CALIFORNIA COASTAL COMMISSION

Re: **SECOND NOTICE OF INCOMPLETE APPLICATION**

Application No. 5-22-0588

Site Addresses: 2102 – 2120 S. Pacific Ave., 2106 – 2116 S. Canal St., 116 – 302 E. N. Venice Blvd., 319 E. S. Venice Blvd., Venice, Los Angeles County, CA 90291

Attachment 1

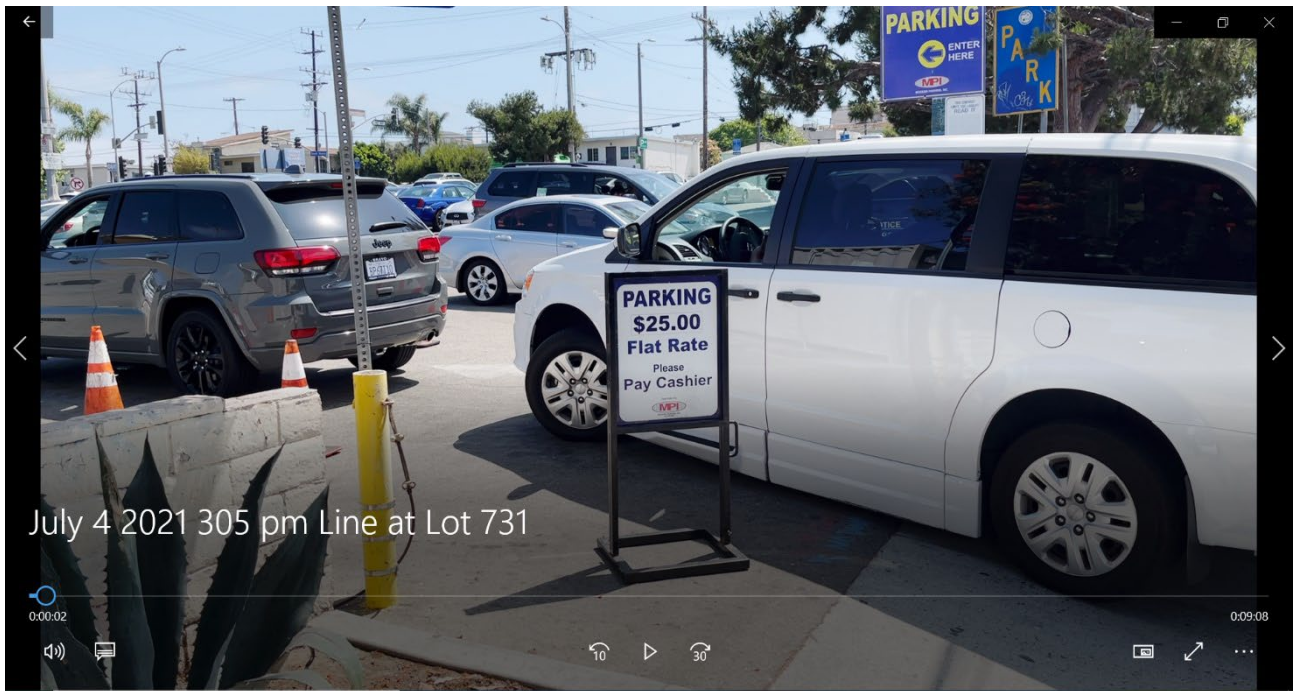
9. **Lots 701 and 731.** Provide a narrative description of the current operation of LADOT Lot Nos. 701 and 731, including the current rates per hour and/or per day for use of the public parking spaces and any changes to the parking rates that have occurred since Commission approval of CDP 5-94-081. **The response letter indicates current hourly and daily rates for Lots 731 and 701 that exceed the rates approved by a 2001 CDP (i.e. \$3-11/day adjusted seasonally.) Provide City records of all hourly and daily parking rate increases since 1994. Clarify the project description by A) providing a summary of rate increases since 1994 and evidence that all rate increases were approved via CDPs, CDP amendments, or Commission Executive Director approved exemptions; or B) revising the project description to request after-the-fact approval for an increase in public parking rates. Additionally, Page 16 of the response letter indicates up to \$25 per hour rates for parking on Thursday through Sunday and holidays. Confirm whether this is an hourly rate or flat rate for a full day. Additionally, staff have received photographs from an appellant showing signs with flat rates and no hourly rates listed (Attachment 1). Provide evidence of signage advertising hourly rates and clarify why hourly payment is not always available.**
